# MAPLE DUNES ADDITION

FINAL PLAN

Re: S/D 96-69 -MAPLE DUNES ADDITION (Final Plat)

Re: S/D 96-69 MAPLE DUNES ADDITION (Final Plat)

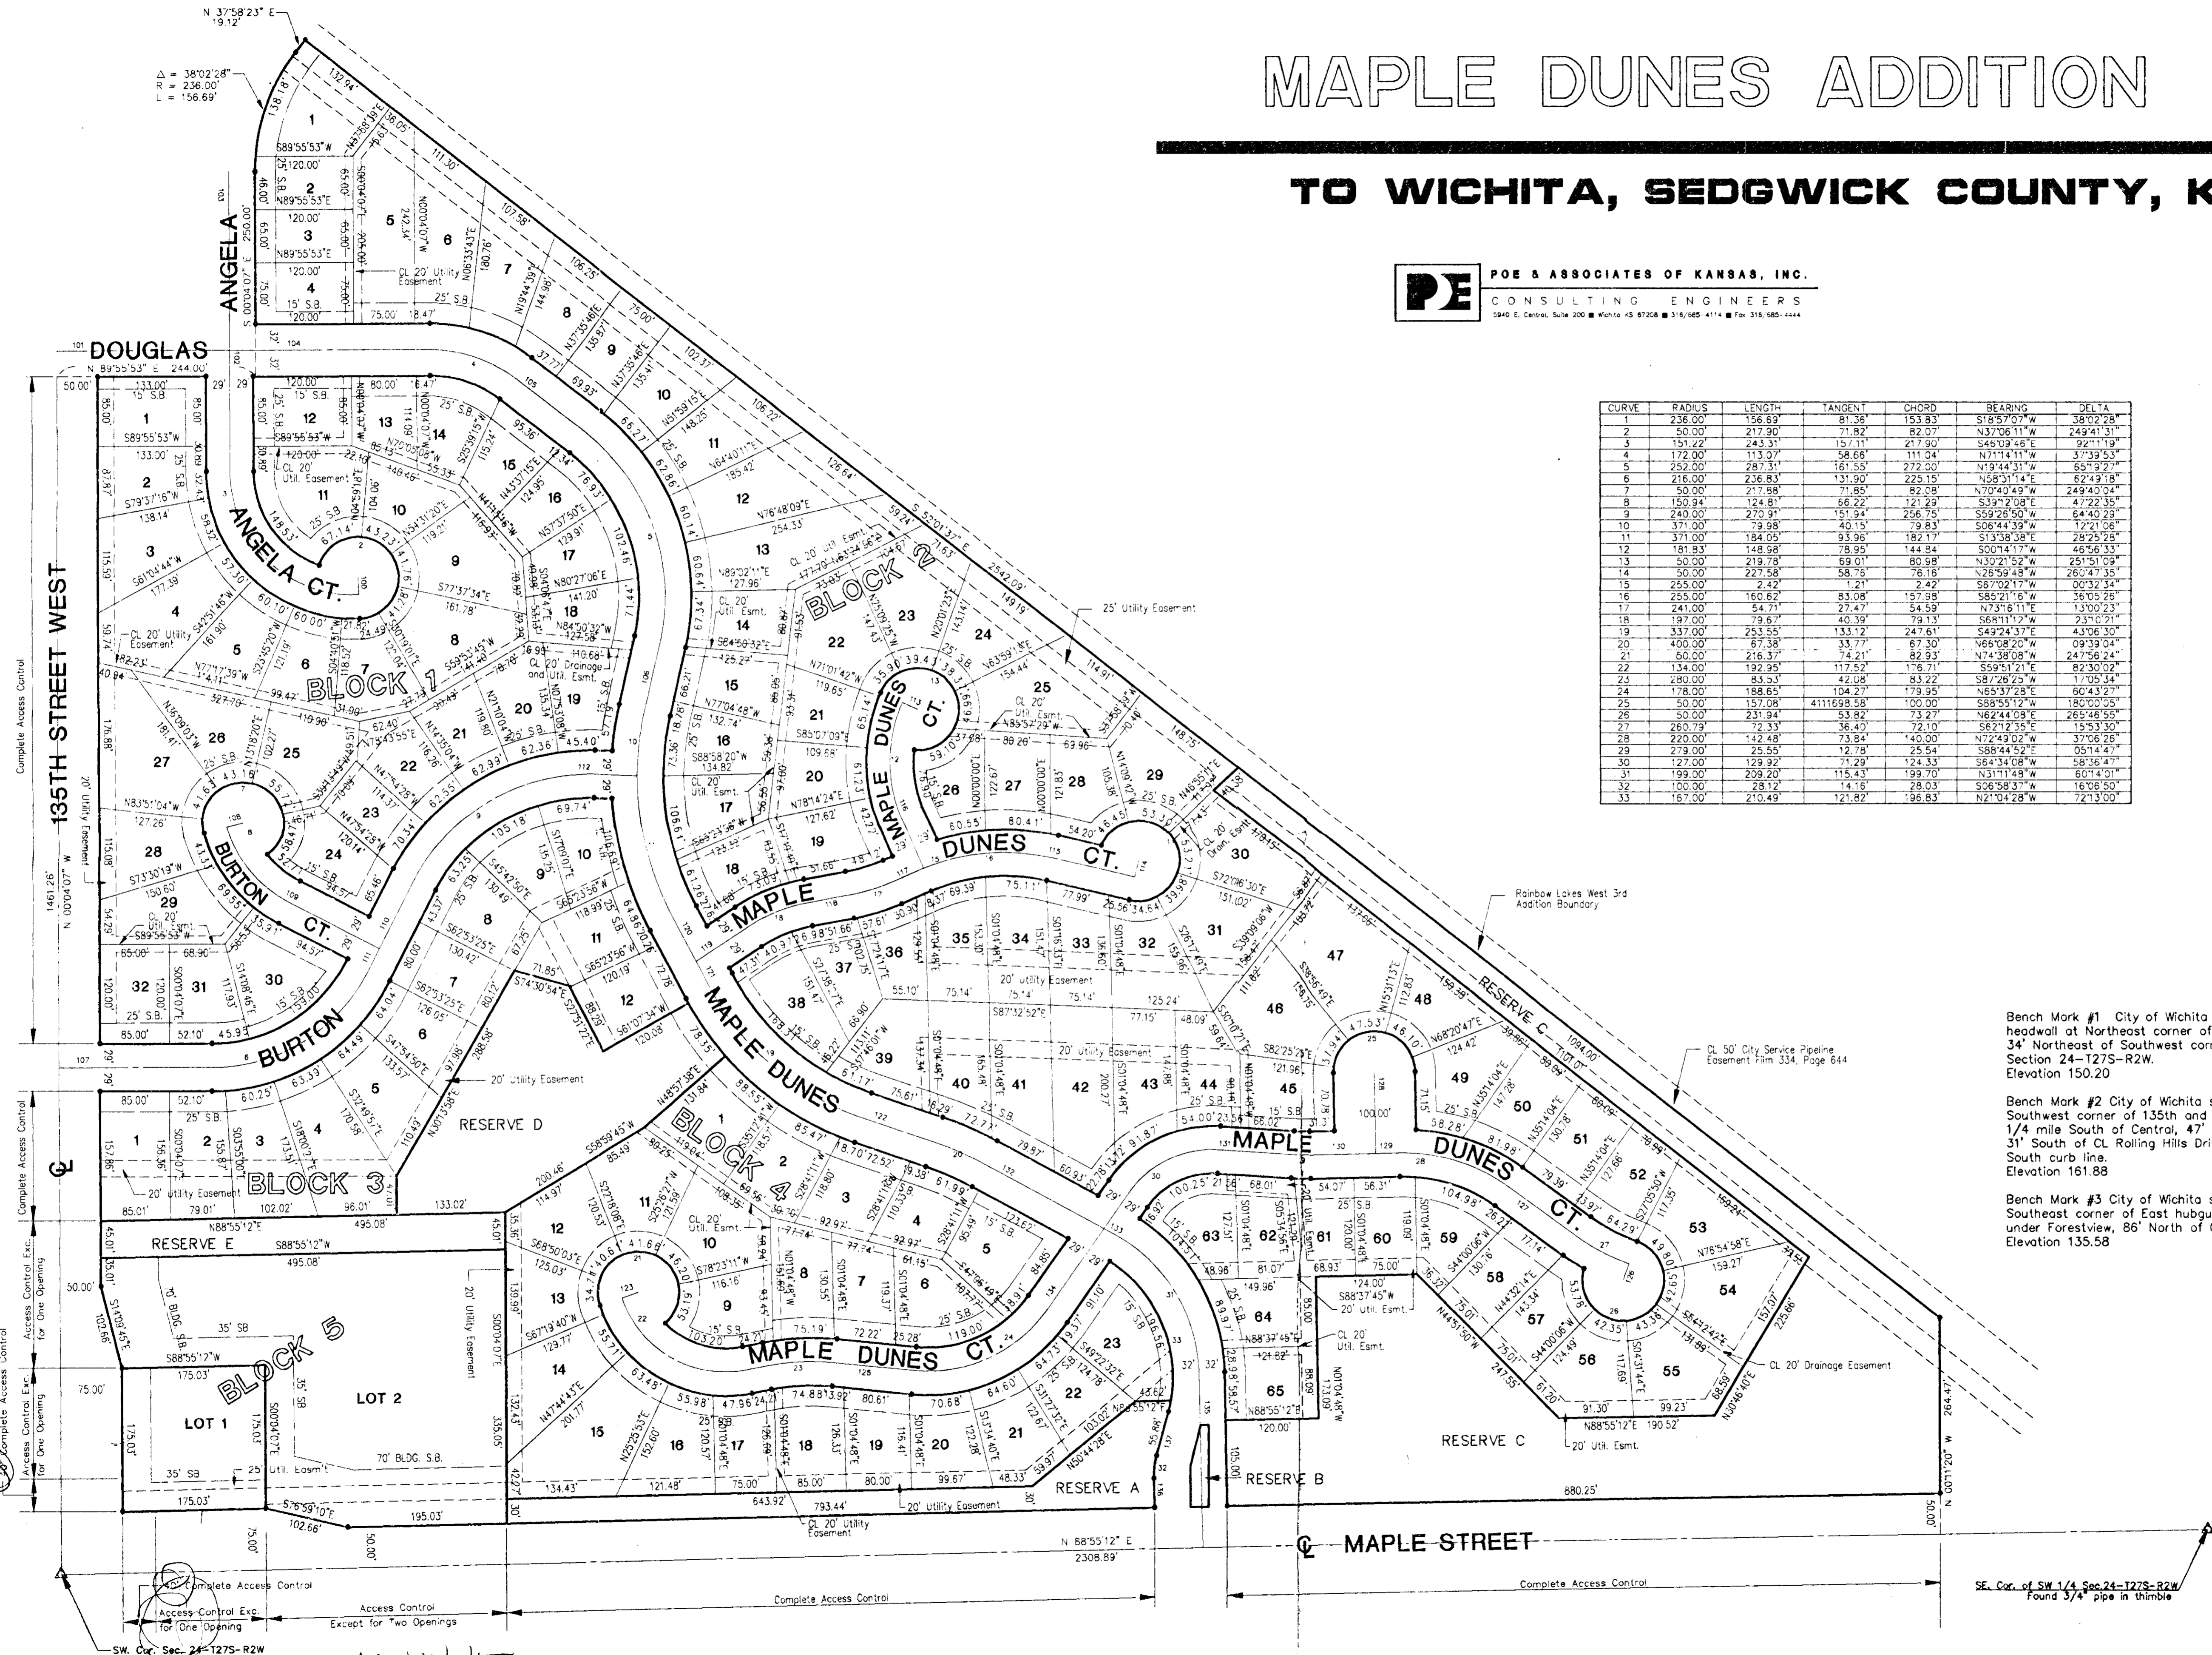
- L. On the final plat tracing, Angela, south of Douglas shall be shown as a Circle and not a Court.
- M. The applicant shall install or guarantee the installation of all utilities and facilities which are applicable and described in Article 8 of the MAPC Subdivision Regulations. (Water service and fire hydrants required by Article 8 for fire protection shall be as per the direction and approval of the Chief of the Fire Department.)

- Q. On the final plat tracing, additional dimensions from lot corners shall be indicated to better locate the easement crossing the rear areas of Lots 1 through 4, Block 3.

- S. Since Minimum Building Pad Elevations are being platted for certain lots, such requirements also need to be noted on the face of the plat. Typically, such minimum elevation requirements are at least referenced, just below the north arrow. The elevations may be listed or reference to the plat's text at least made. These elevations need to be shown in both City datum and MSL. Also, as indicated by Engineering, such elevations need to be shown for the other lots adjacent to Reserve C (Lot 30, and Lots 47 through 53).

- T. In regard to access controls as established in the plat's text, the openings associated with Lots 1 and 2, should also include reference to Block 5.

- U. On the final plat tracing, the reference to Reserve C along the northeast line of the plat (Lots 30 and 47 through 53, Block 2) shall be clearly indicated as the area lying between the lots and this plat's perimeter. The wording "Reserve C" should either be placed within this area, or an arrow extending from the present wording in this area.

- V. On the final plat tracing, the reference to the "25 Util.Esm't and Bldg. Setback Line" along the northeast line of the plat shall further note that the Setback Line is a "Bldg. Setback Line for the City Service Pipeline." That is, the setback function of this line is not a platted setback but is rather a private matter controlled by the holder of the pipeline easement.

- James Alford, County Clerk
    - Larry Consolver, Register of Deeds
    - Michael D. Hurtt, Deputy Register of Deeds.
- X. On the final plat tracing, additional dimensional information shall be provided for the width of the opening (right-of-way) of Maple Dunes at Maple Street and to describe Reserve B at that location.

- AA. As requested by the City's Fire and GIS Departments on the final plat tracing, the street name Douglas shall be placed in the area of Lot 7, Block 2, with Maple Dunes shown from that point southward. The name Maple Dunes shall also be shown just north of the site's entrance off of Maple.
- BB. Also, as noted by City Engineering, oil well equipment, including storage tanks are shown as encumbering easements on certain lots in this Addition. Prior to this plat being scheduled for City Council review, the applicant shall submit a letter indicating that all such structures, encumbrances, etc. have been removed from any area being platted as an easement.
